SERVICE No. 301A BULLETIN

Piper Aircraft Corporation

November 25, 1969

Reissued Airplane Flight Manual and New Placards (Reference FAA Airworthiness Directive for PA-30 dated

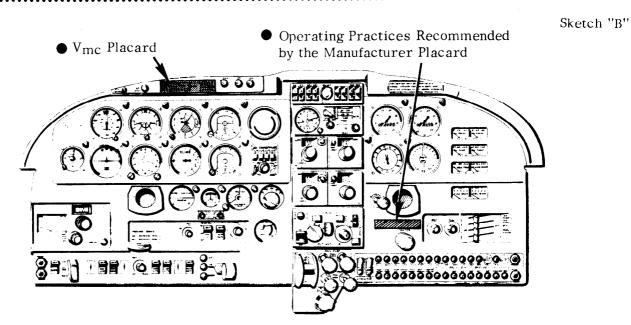
- I. Aircraft serial numbers 30-1 to 30-1716, 30-1718 to 30-1744 incl.:
 - A. Remove or cover existing minimum single engine control speed placard and install new Vmc placard, per sketch A, page 3 of this bulletin.
 - B. Install new operating practices recommended by the manufacturer placard, located as denoted on Sketch A, page 3 of this bulletin.
 - C. Replace existing Section 1, Airplane Flight Manual Report No. 1269 with reissued Section 1 (reissue date 11/15/69), Airplane Flight Manual Report No. 1269, supplied with Vmc Placard Installation Kit part number 760 354 (reference Material Required, below).
- II. Aircraft serial numbers 30-1717, 30-1745 to 30-2000 incl.:

- A. Remove or cover existing minimum single engine control speed placard; install new Vmc placard per Sketch B, page 3 of this bulletin.
- B. Install new operating practices recommended by the manufacturer placard, located as denoted on Sketch B, page 3 of this bulletin.
- C. Replace existing Section 1, Airplane Flight Manual Report No. 1515 with reissued Section 1 (reissue date 11/15/69), Airplane Flight Manual Report No. 1515, supplied with Vmc Placard Installation Kit part number 760 355 (reference Material Required, below).
- III. Page 7a (revised 6/30/69) of Weight and Balance Section of Airplane Flight Manual Report Nos. 1269 and 1515, previously supplied with Service Bulletin No. 301, dated August 29, 1969 is not to be discarded, but must remain with the Airplane Flight Manual.
